TO: Winton
COPY TO: David Osbourne
FROM: Laura Drummond

Date: 21 November 2025
Job No: 65507

SUNFIELD FAST TRACK APPLICATION – STREAM ECOLOGICAL ASSESSMENT

Figure 1. Location of the representative SEVs within the Sunfield project area

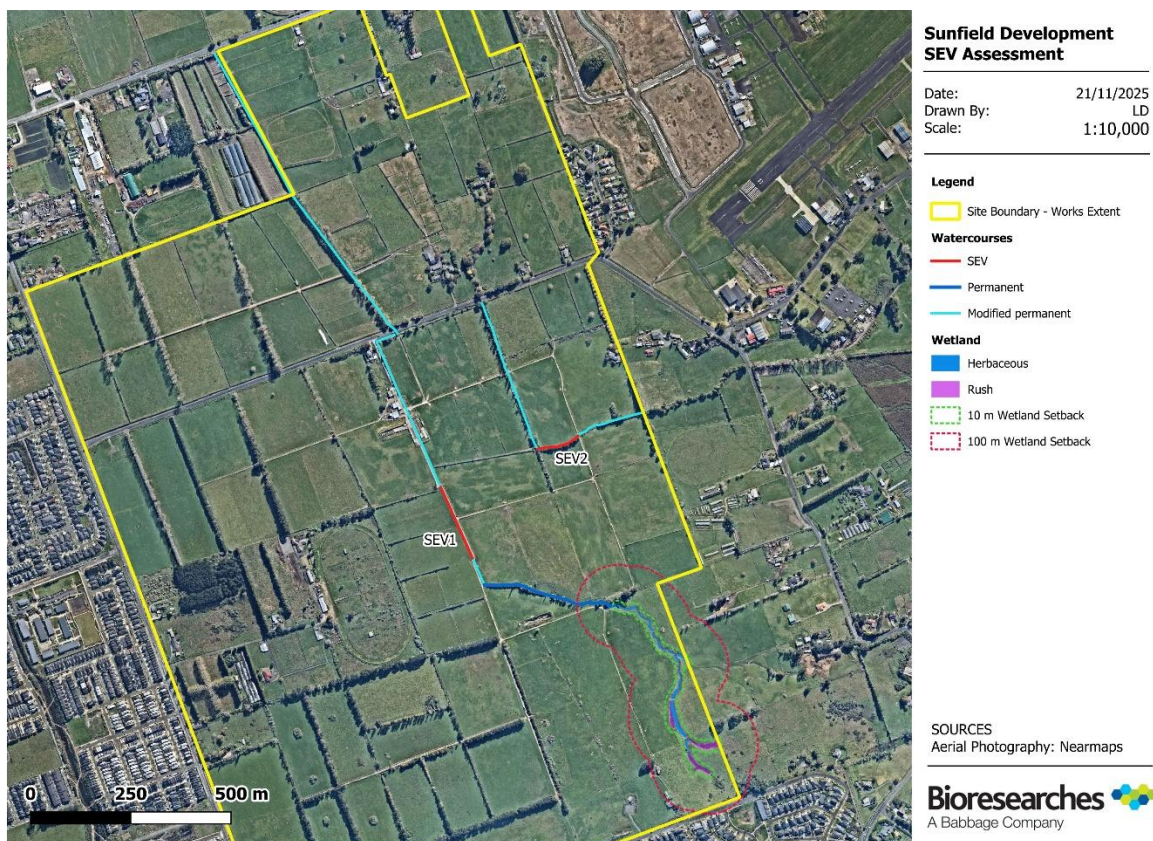
“Has the applicant demonstrated, through recognised modelling, that the proposed stream diversion and culverting will achieve no net loss of ecological values, particularly given the dual stormwater management function of the diversion channel?”

Note: *Biodiversity enhancements may be constrained in areas that also serve stormwater management functions. No modelling has been provided to demonstrate the ecological or biodiversity values that would be achieved along the proposed diversion channel. It is recommended that modelling be undertaken using a recognised methodology, such as Auckland Council’s Stream Ecological Valuation (SEV) and Ecological Compensation Ratio (ECR), to quantify expected ecological outcomes and confirm compliance with proposed consent conditions requiring an overall net gain.”*

An ECR of 0.61 was calculated for SEV1, and 0.94 for SEV2, which would equate to the loss of stream values associated with 1 m of stream length in SEV1 requiring 0.94 m of stream length on the diversion channel to ensure stream values are retained. Similarly, SEV2 has an ECR score of 1.00, indicating no loss of ecological values. It is important to note these are based on the potential value of the existing watercourses, rather than their current state indicating an overall net-gain would be achieved. When replacing SEVi-P with SEVi-C values, the ECR scores is 0.63 (SEV1) and 0.83 (SEV2).

Overall, it is considered the creation of the diversion channels will not result in a reduction in freshwater ecological values, considering the dual use as stormwater conveyance channels, rather a gain in ecological values will be achieved.
